KEYSTONE XL PIPELINE PROJECT - STEELE CITY SEGMENT PIPELINE ROUTE VARIATION FORM			
1	<b>VARIATION TYPE:</b>		
	Refinement: <input type="checkbox"/>	<input checked="" type="checkbox"/>	Reroute: <input type="checkbox"/>
	Centerline: <input checked="" type="checkbox"/>	Valve Site: <input type="checkbox"/>	Pump Station: <input type="checkbox"/>
2	<b>LOCATION:</b>		
	Sketch: <input type="checkbox"/>	<input checked="" type="checkbox"/> Attached	Pictures: <input type="checkbox"/>
	State: <input type="checkbox"/>	<input type="checkbox"/> SD	County: <input type="checkbox"/>
	Township: <input type="checkbox"/>	<input type="checkbox"/> 2N	Range: <input type="checkbox"/>
	Section: <input type="checkbox"/>	<input type="checkbox"/> 23, 24	Centerline: <input type="checkbox"/>
		<input type="checkbox"/> 3/26/2010	MP: <input type="checkbox"/>
		<input type="checkbox"/>	to <input type="checkbox"/>
		<input type="checkbox"/>	<input type="checkbox"/> 470.59 to <input type="checkbox"/> 471.48

KEYSTONE PIPELINE PROJECT - U.S. PHASE IV (STEELE CITY SEGMENT) ROUTE VARIATION AUTHORIZATION FORM			
Date: <input type="text" value="11/9/2010"/> Description: <input type="text" value="Reroute to avoid side slo

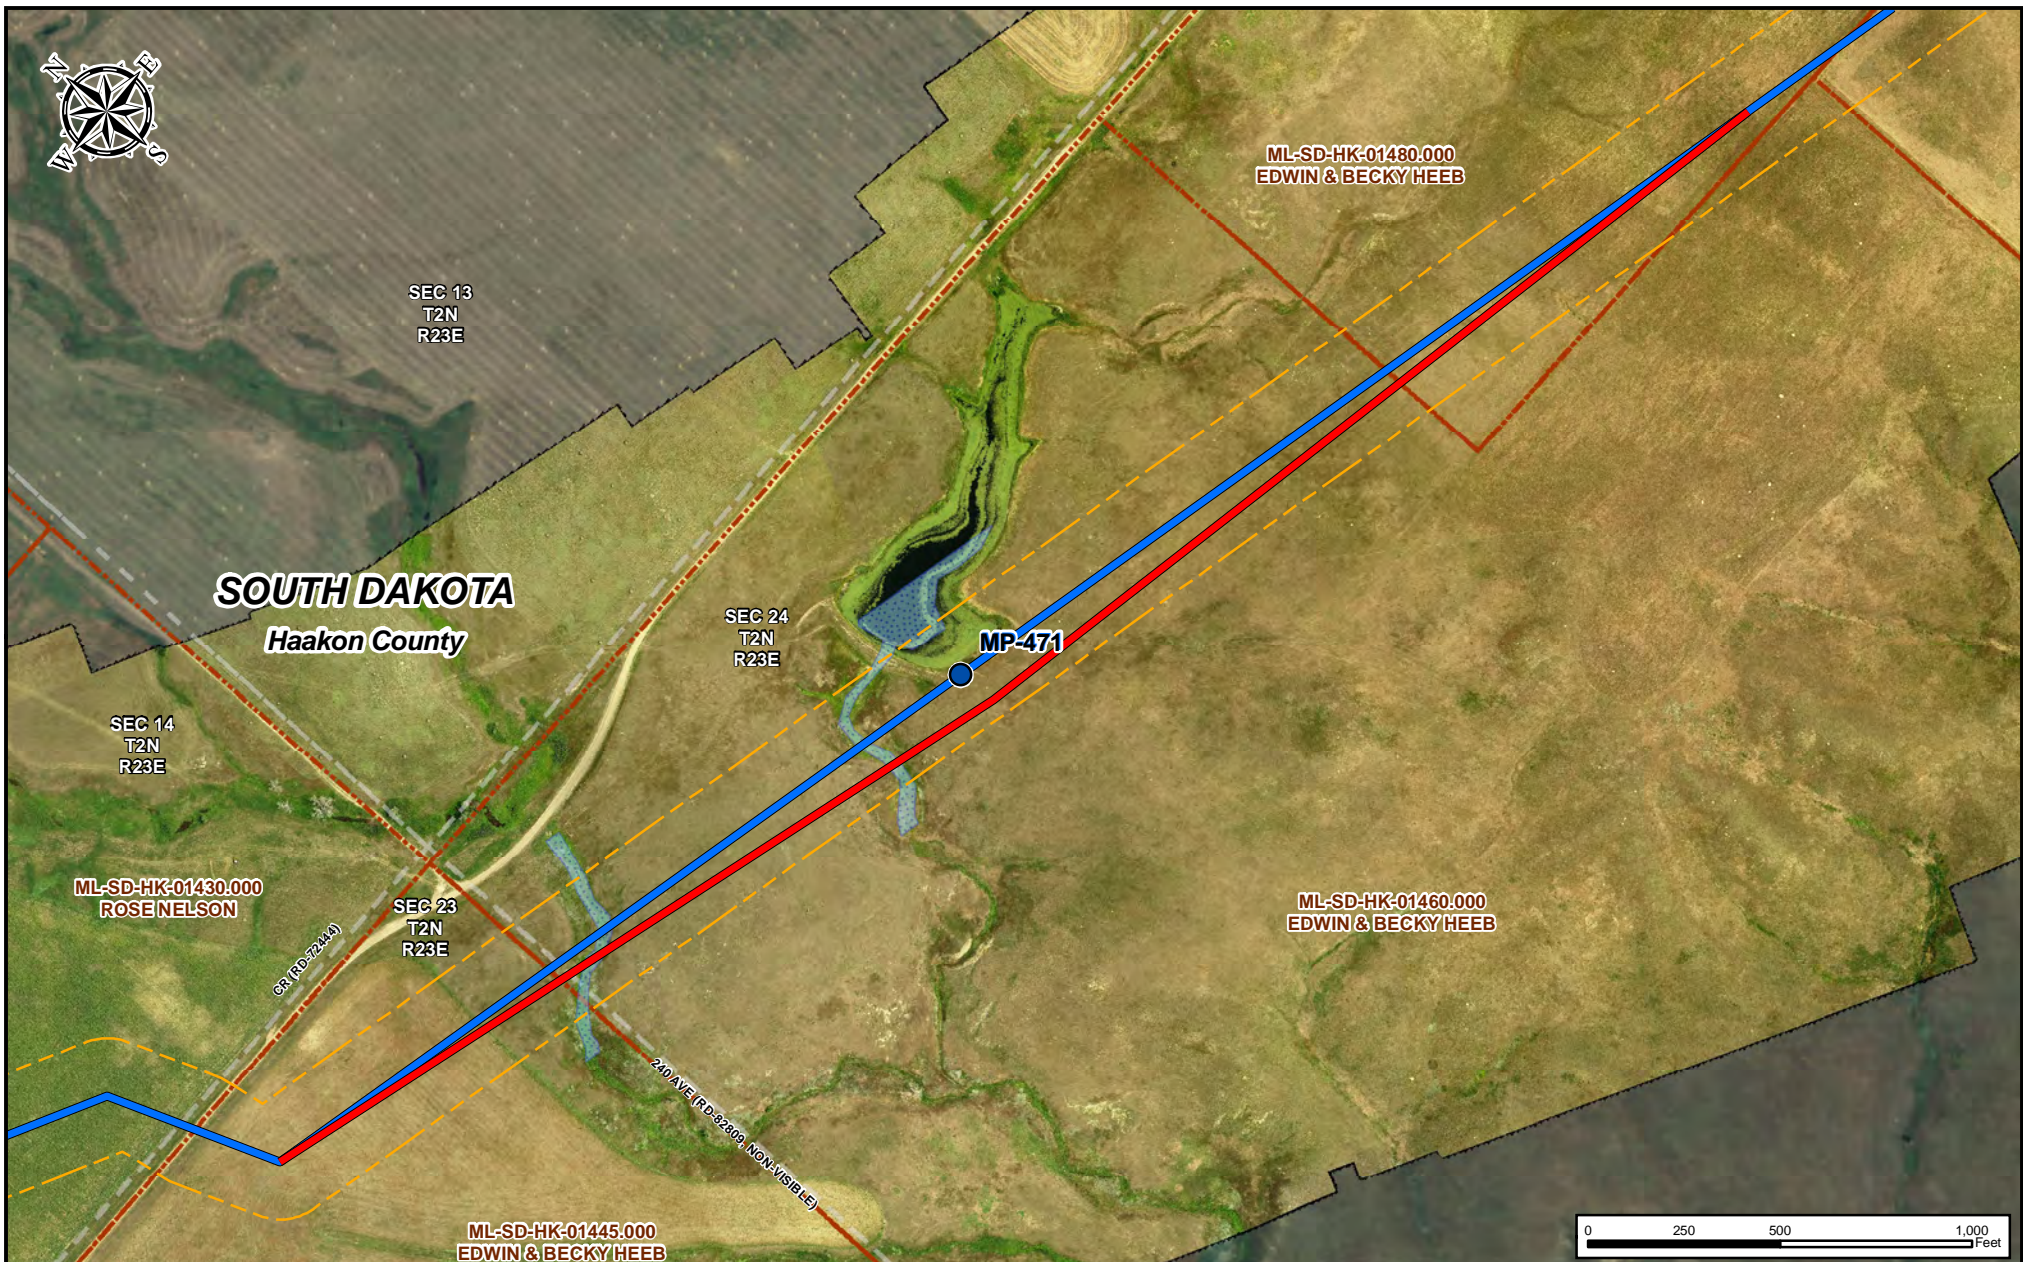
3	<b>REASON FOR ROUTE VARIATION</b> (Please include reason for route variation):		
<p>This reroute is proposed to accommodate landowner's (ML-SD-HK-01460, Edwin &amp; Becky Heeb) request to avoid any construction impacts to the side slope of a pond on the landowner's property.</p>			
<b>DETAIL ROUTE VARIATION</b> (Please describe route variation in detail):			
<p>The proposed reroute starts at the PI near MP 470.6 and deviates slightly (~3") away from the centerline towards the southeast. It continues in this direction for 2,210 ft towards until it completely avoids having any construction impacts to the pond to its northeast. From here, the centerline turns toward the east and continues for ~2,490 ft to rejoin the current centerline at ~MP 471.5.</p> <p>The proposed reroute is civil surveyed by consulting with the landowner.</p>			
<b>ADDITIONAL IMPACTS</b> (Please include any additional impacts which may affect cost; crossings, induction bends, etc.):

<p>The proposed reroute is ~5 ft longer than the current route.</p>			
Is there an increase/decrease in the number of crossings? Yes <input type="checkbox"/> No <input checked="" type="checkbox"/>			
If yes, please list: <input type="text"/>			
<b>COST ANALYSIS</b> (costs incurred or saved from the route variation)			
Additional length of route realignment:	<input type="text"/>	ft.	\$ <input type="text"/>
Additional length of side-hill construction:	<input type="text"/>	ft.	\$ <input type="text"/>
Additional length of wetland construction:	<input type="text"/>	ft.	\$ <input type="text"/>
Additional bore length (Road, RR):	<input type="text"/>	ft.	\$ <input type="text"/>
Additional foreign line/pipeline crossings:	<input type="text"/>	EA	\$ <input type="text"/>
Additional water body crossing (streams, ponds, etc.):			
	35 - 65' +	<input type="text"/>	EA \$ <input type="text"/>
	10' - 19'	<input type="text"/>	EA \$ <input type="text"/>

a) Maximum deviation perpendicular to proposed alignment: 100 ft.

<b>Trow - Environmental</b> Jonathan Minton Comments: <input type="text"/>	Variation: Approved <input checked="" type="checkbox"/> Rejected <input type="checkbox"/> <i>Jonathan Minton</i> Date: <input type="text" value="11/10/2010"/> If Rejected Why? <input type="text"/>		
<b>AECOM -Risk Assesment</b> Heidi Tillquist Comments: <input type="text" value="This reroute does not significantly alter risk to HCAs and is therefore acceptable from a risk perspective."/>	Variation: Approved <input checked="" type="checkbox"/> Rejected <input type="checkbox"/> <i>Heidi Tillquist</i> Date: <input type="text" value="11/15/2010"/> If Rejected Why? <input type="text"/>		
<b>Project Management</b> Butch Wallace Comments: <input type="text"/>	Variation: Approved <input checked="" type="checkbox"/> Rejected <input type="checkbox"/> <i>R.E. Wallace</i> Date: <input type="text" value="11/16/2010"/> If Rejected Why? <input type="text"/>
